TECHNICAL INFORMATION

SUBJECT: Nylon line cutter **SF400** on **ECHO** and **shindaiwa** trimmer

Number: Y2020-690
Issued: Aug. 31, 2020

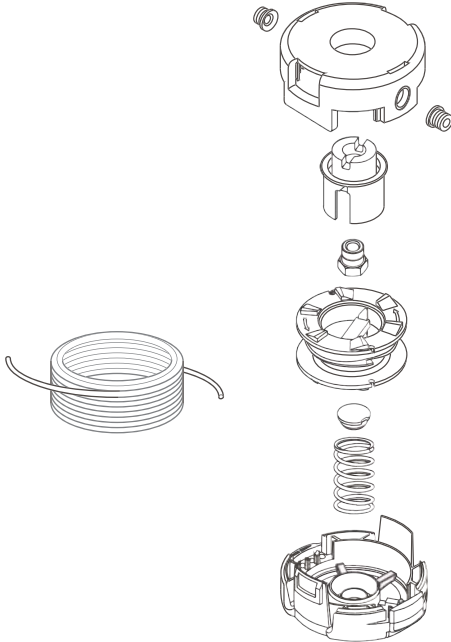
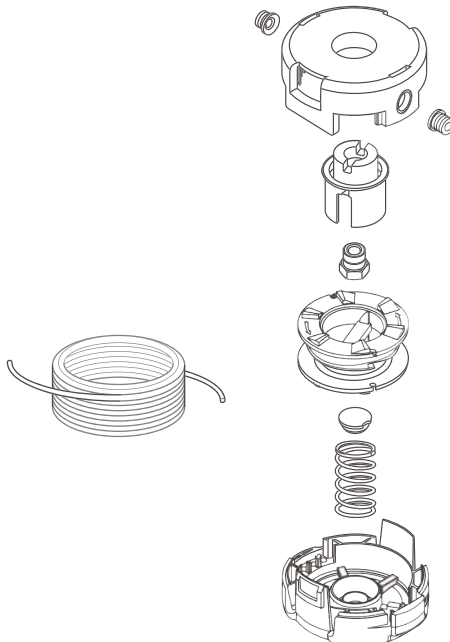
Improved nylon line cutter to decrease sticking grasses.

Washer Regulator knob	<p>V332-000090 </p> <p>E415-000180 </p> 	<p>Nil</p> <p>E415-000240 </p> 
<p>Regulator knob E415-000240* can be used on the unit before this change.</p>

*without washer V332-000090
